**Subject: Response to Request for Additional Information letter dated November 26, 2013 for the application for Certificate of Compliance No. 9365 for the Model No. RT -100 package.**

**Reference: 1) Docket No. 71-9365 and TAC No. L24686  
2) USNRC Request for Additional Information dated November 26, 2013  
3) Revision 3 – Safety Analysis Report for the RT-100 Package dated January 14, 2014**

**Robatel Technologies Response to the  
NRC Second Round of Request for Additional Information  
for the  
Model N° RT-100 Package  
Docket N° 71-9365**

**Figure 1- Upper Impact Limiter Dose Rate Response for Co-60**

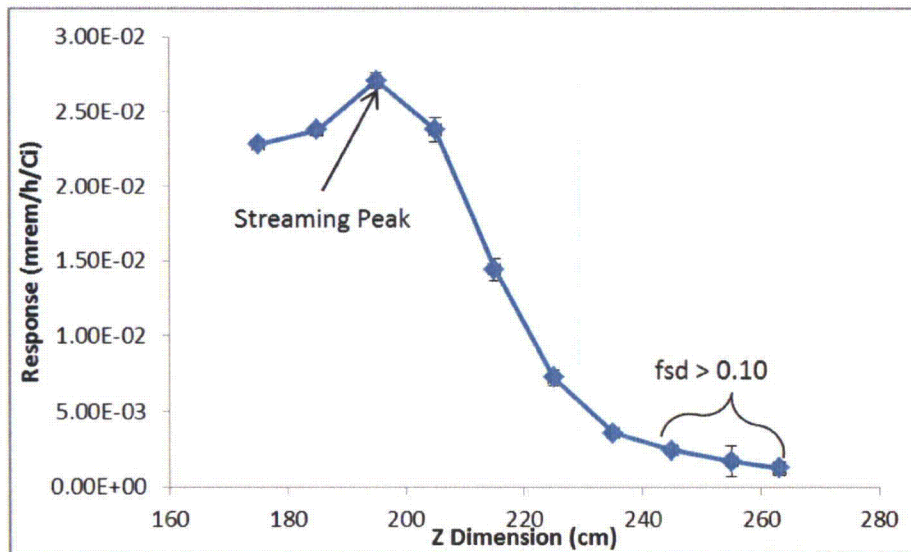
In addition, the staff's confirmatory calculations using the applicant's models indicated that most of the low mid-to-low energy particle MCNP calculations do not converge with the time specified in the models and the applicant confirmed this during a meeting. Hence, the results presented to the NRC in the application might have been erroneous and misleading. The applicant needs to provide results that are accurate and reliable.

The dose rate response for the upper impact limiter for Co-60 is plotted in Figure 1. In Figure 1 it is shown that the peak dose rate locations are captured by the tally, and the upper end of the upper impact limiter does not contain a peak location. A similar illustration is presented for Cs-137 in Figure 2, and the same conclusions can be drawn.

Figure 8.1.4-5. Test Apparatus for Measuring the Helium Leak Rate through the Quick Disconnect Valve Cover Plate

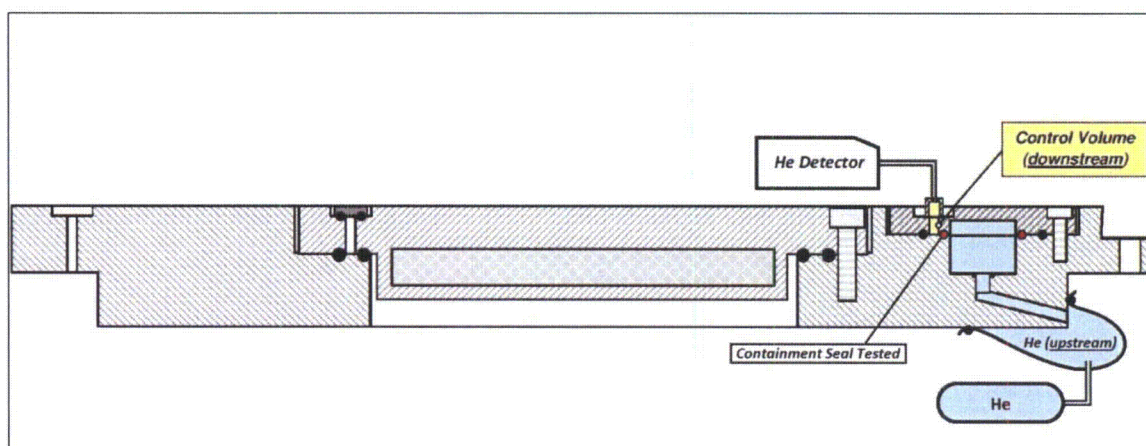
Clarify the quick disconnect valve and quick disconnect valve cover plate leakage test procedures.

The quick-disconnect valve and its cover plate can be tested either with the primary lid off or on the cask body. In the first configuration with the primary lid off, a bag containing helium is attached to the lower portion of the primary lid. In the alternate configuration with the primary lid on, the secondary lid is removed, the secondary lid opening is sealed with plastic sheet and taped, and a penetration through the plastic sheet is used to inject helium into the cask cavity. The only difference in the configurations is how the helium is injected. The containment boundary and the test method are identical. Sections 8.1.4.3 and 8.1.4.4 have been updated to include figures to show the test configurations. Figures 8.1.4-5 and 8.1.4-6 from the SAR have been provided below for reference.
